**ALLENDALE CHARTER TOWNSHIP
PLANNING COMMISSION MEETING**

To: Allendale Charter Township Planning Commission
From: Gregory L. Ransford, MPA 
Date: October 12, 2021
Re: 6138 LMD Planned Unit Development – Final Plan

RE: 6138 Lake Michigan Drive. Review comment responses from letter dated 8.25.2021

6138 LAKE MICHIGAN DRIVE
ILLUSTRATIVE SITE PLAN RENDERING
project number: 18201950

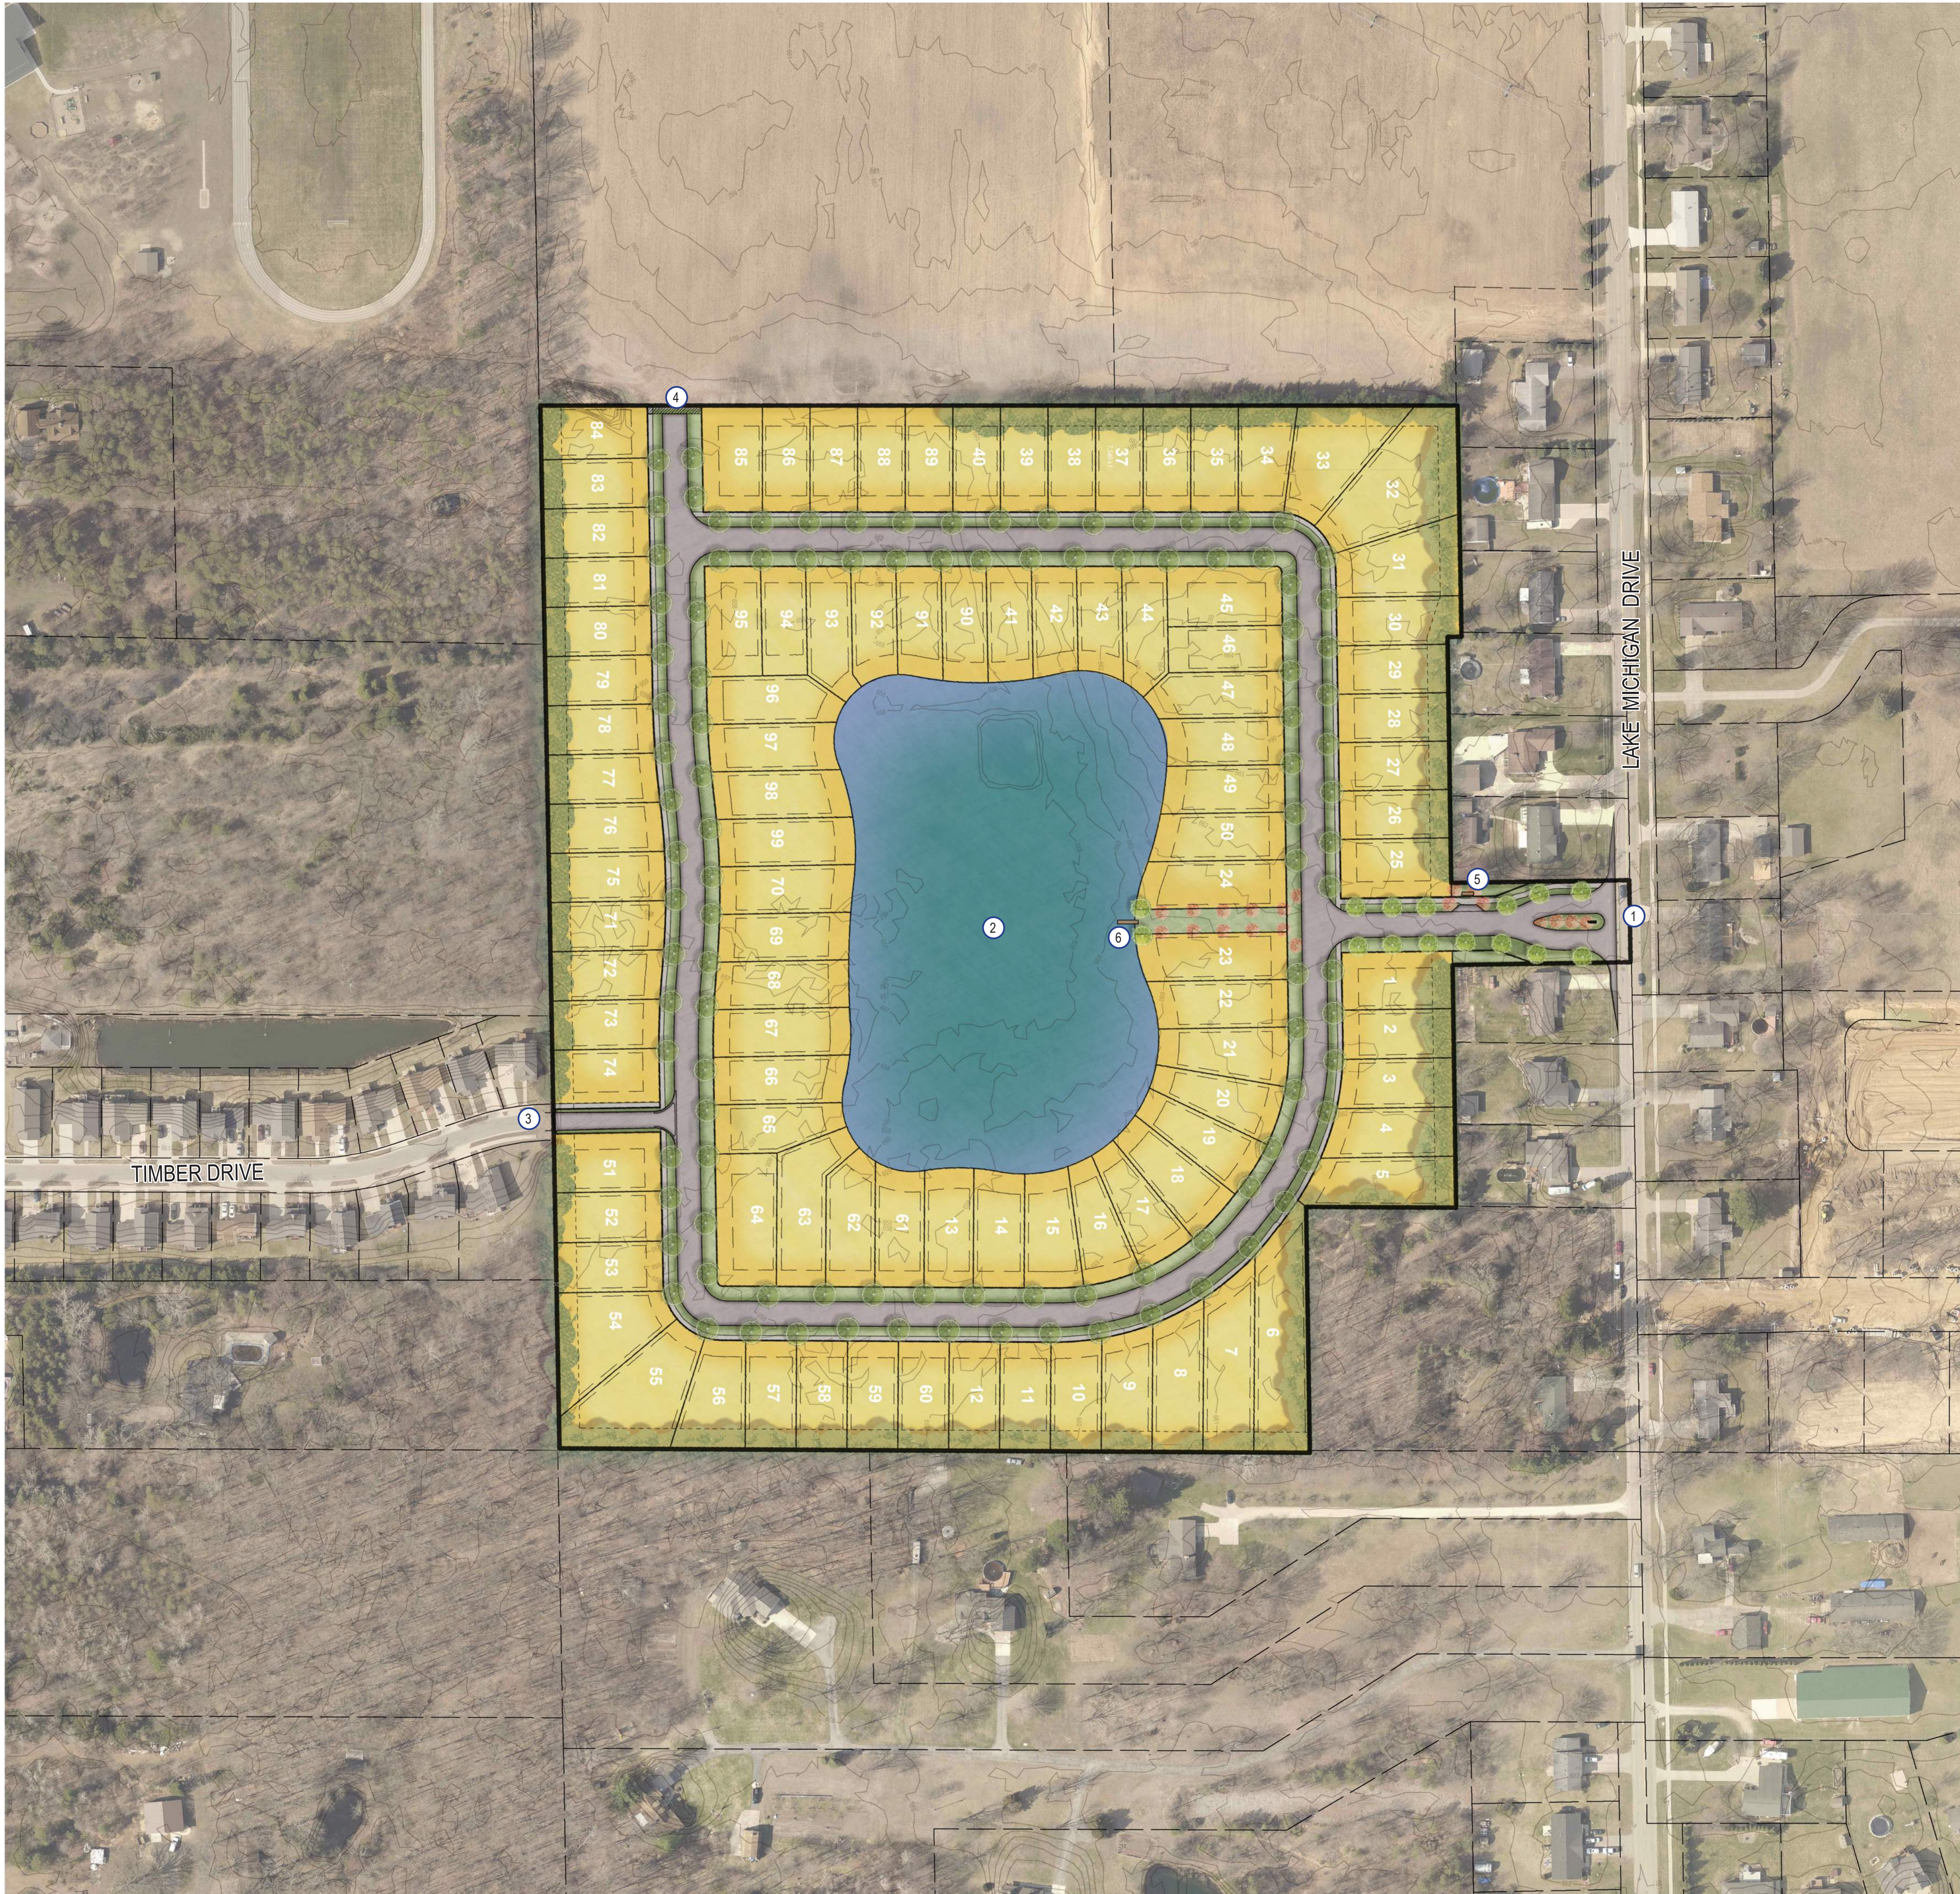
- o Circle 3 – Please provide details how this will be achieved, especially at the water's edge

Site Layout Plan

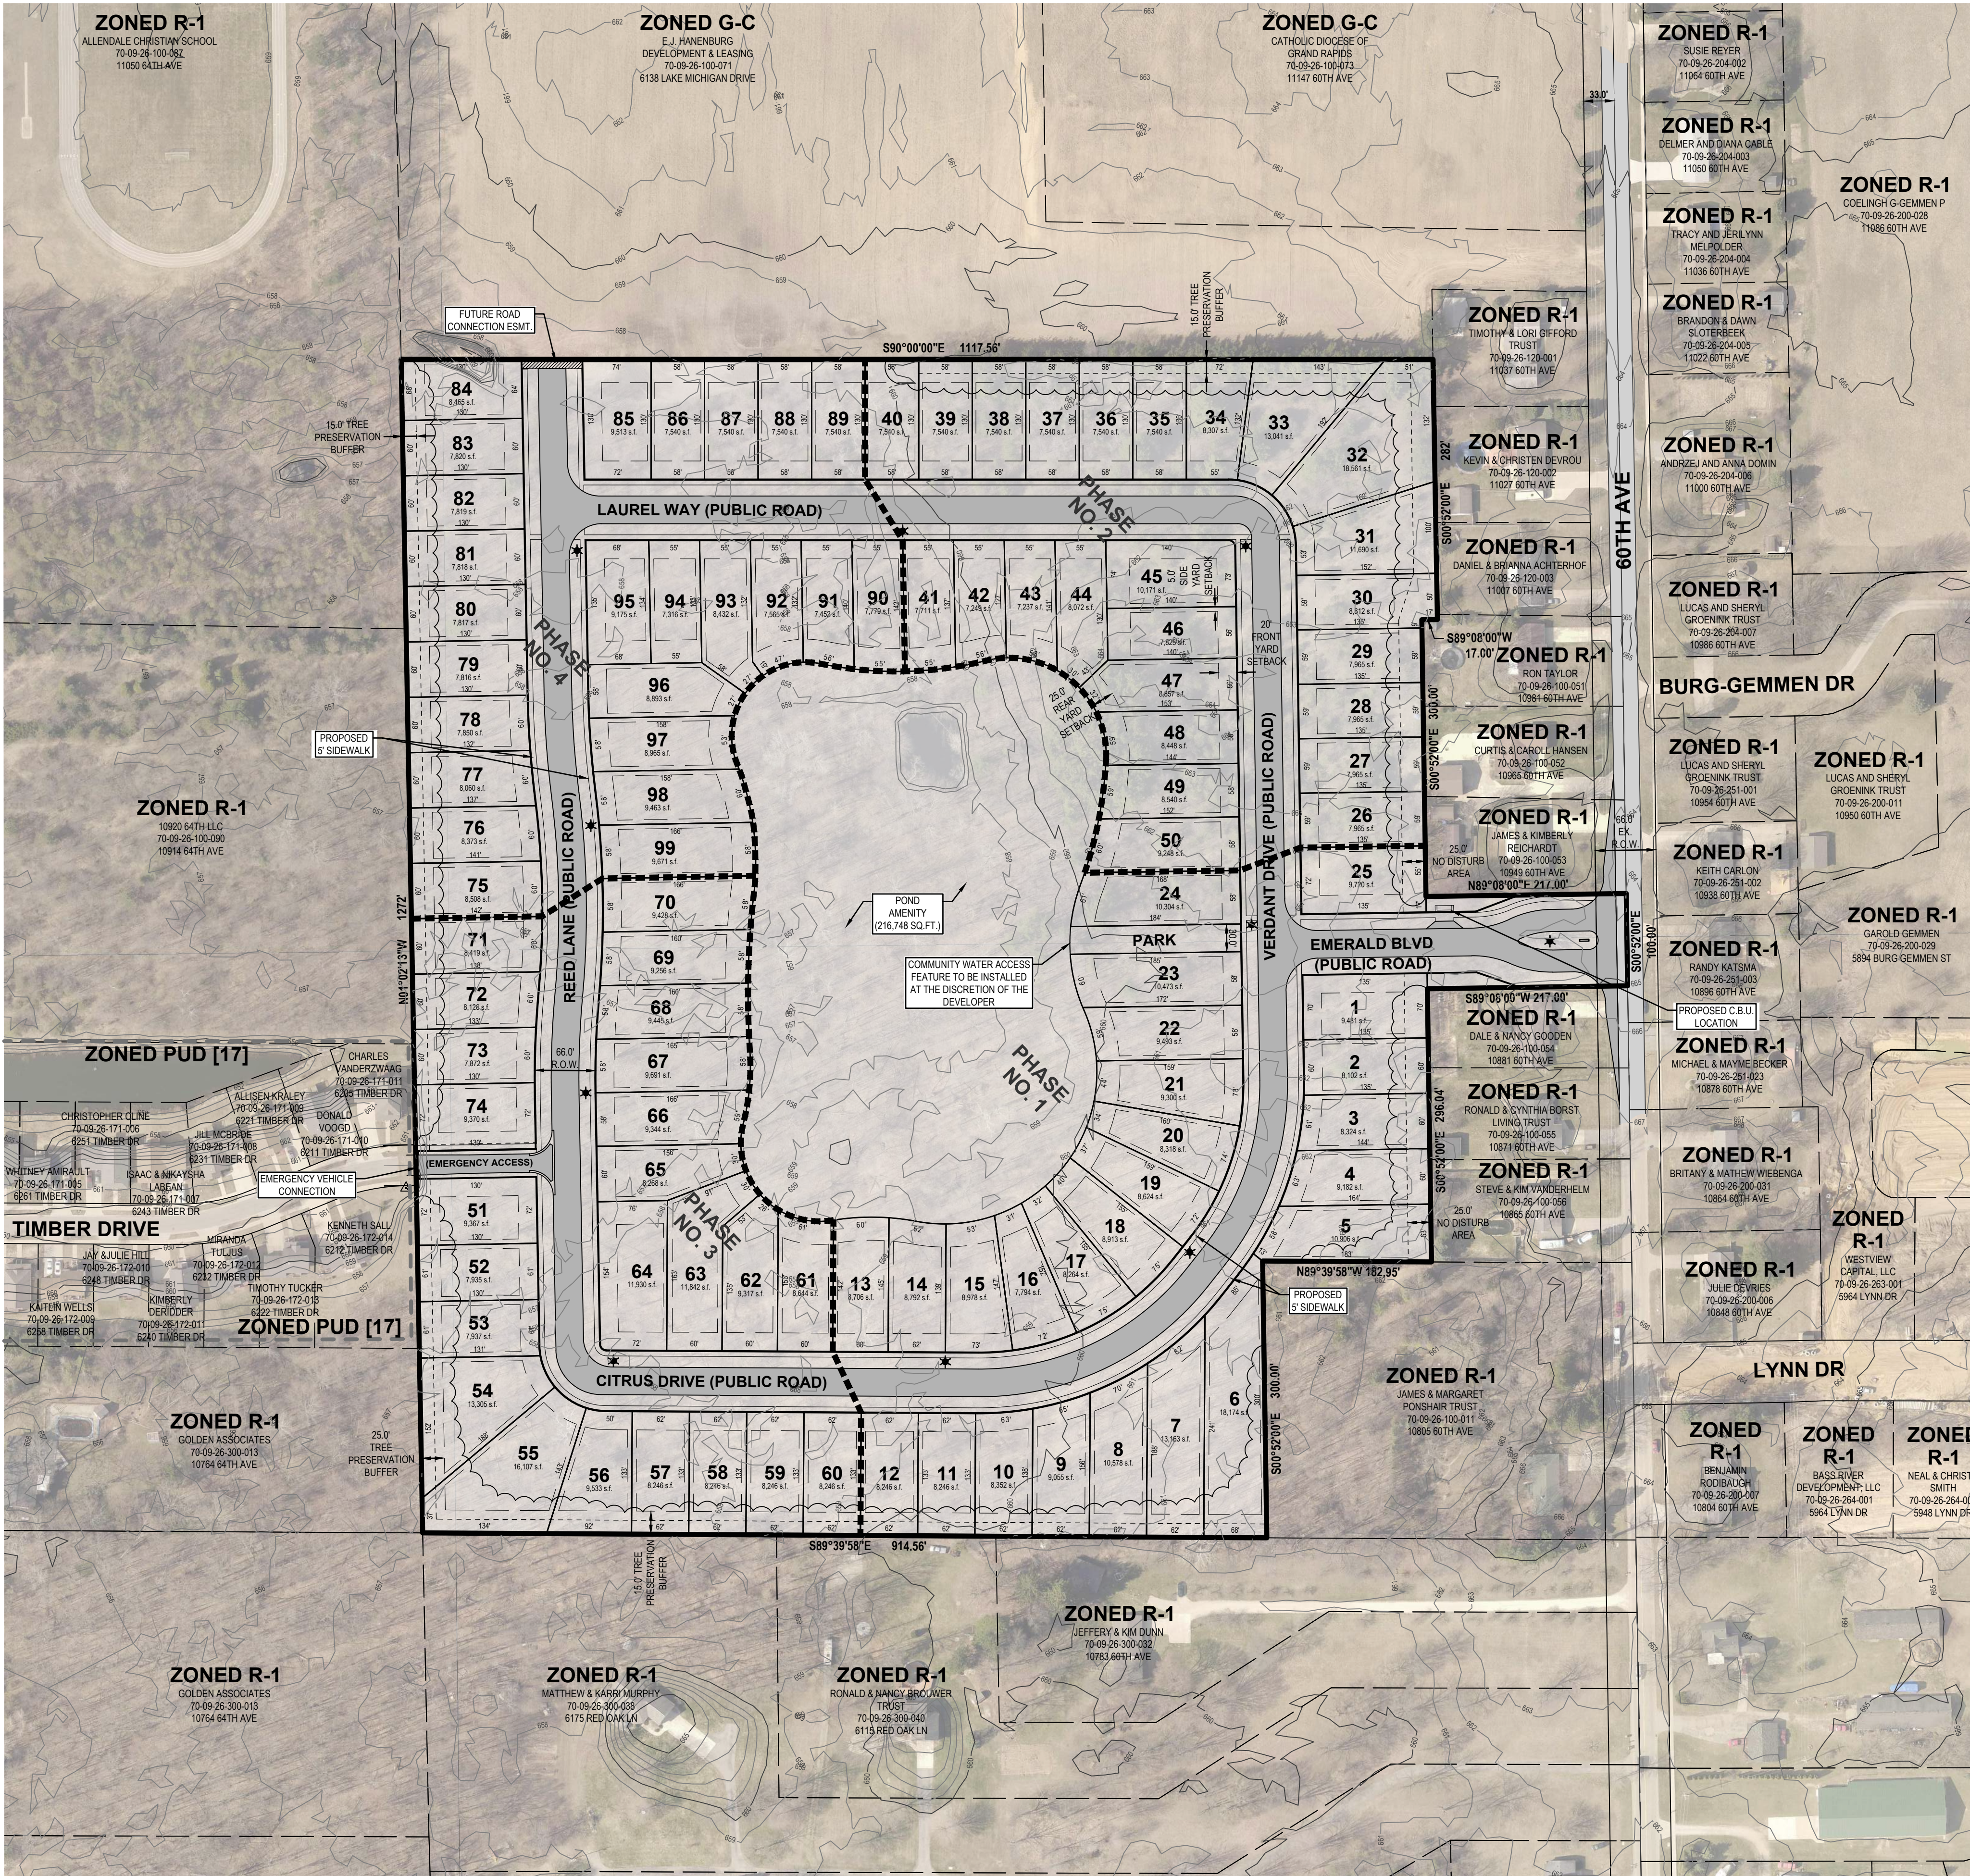
General Note #10 indicates that the street trees will be planted pursuant to the Ottawa County Road Commission (OCRC) requirements. As you are aware, the Township recently amended the related street tree language to address any requirements from the OCRC and the Allendale Charter Township Subdivision Ordinance regulates trees in this regard. While the applicant indicated in their undated response letter included with their submission that this note was updated, we wanted to highlight that it remains incorrect. Nonetheless, during the plat application process, the street trees will be addressed accordingly.

- For your math shown, we suggest subtracting half of the pond to keep your calculations consistent with General Note #6 on Sheet C-201

- o General Note #10 should be based on the township requirements *Added.*

- o General Note #11 – Please provide street light locations on the plan, specifications sheets, and areas of illumination. This was an important comment from the public during the preliminary plan review.

Added all of above. L200 plan shows this.
